Prudent Fashions Ltd

Gazir Chart Alia Madrasa, Kaichabari Road, Dhamsona Ashulia, Dhaka-1344
(23.947001N, 90.269128E)
12 October 2021

Observations

Floor live load plan do not comply with BNBC

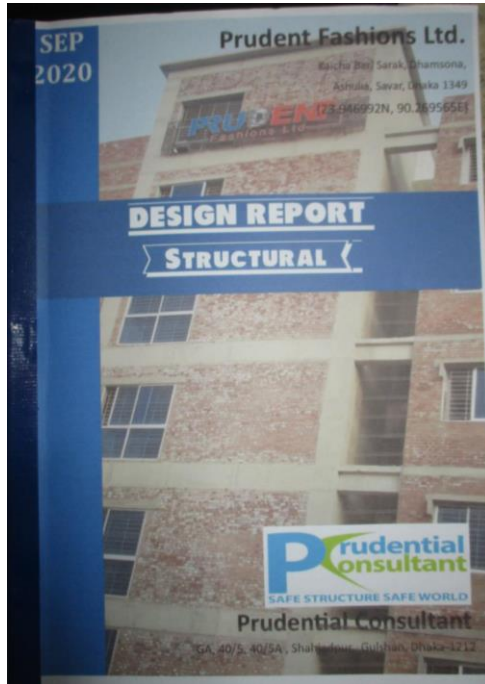
Floor live load plan with 105 psf (5 kN/m²) loading limit

As per BNBC, the minimum floor live load for light storage is 6 kN/m² (125 psf). The storage in this building is designed for 5 kN/m² live loads. The building engineer is required to revise the storage live load limit based on BNBC requirement and update the load plan and design report accordingly.

Irregular building plan

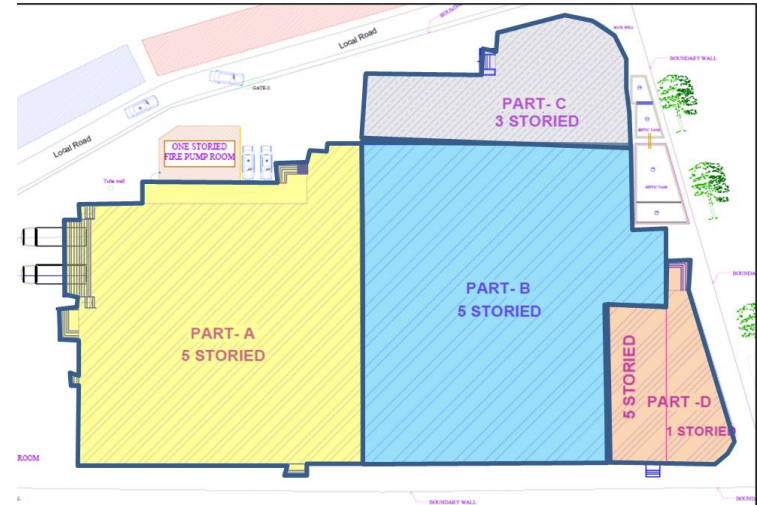
The shape of building-1 is irregular. There are four building parts and three expansion joints. During seismic event, movement of building parts may be different. The part-D has no shear wall and partially 5 storey. The position of shear walls are not symmetric.

The building engineer to incorporate irregularities check in the design report and suggest required recommendations.

The ground floor column of part C & D

The ground floor height is 6.0 m. The diameter of column of part C is 375 mm and width of column of part D is 375 mm. The building engineer to check the slenderness effect for those columns and incorporate the design in the report.

Column susceptible to vehicle impact

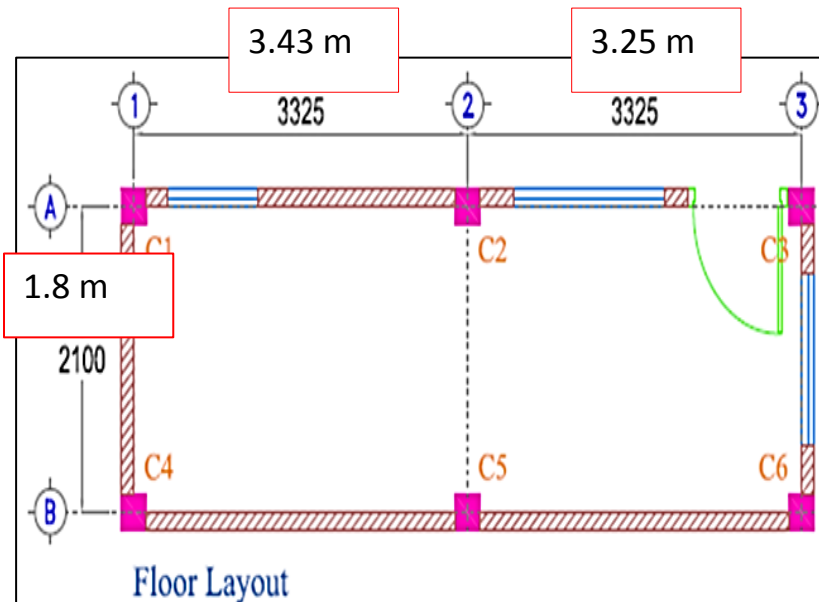
Column in loading/unloading areas have no safety barrier.

Column in loading/unloading areas have no safety barrier which are susceptible to possible vehicle impact. Factory is required to provide barrier around all the exposed columns to protect the columns from possible vehicle impact.
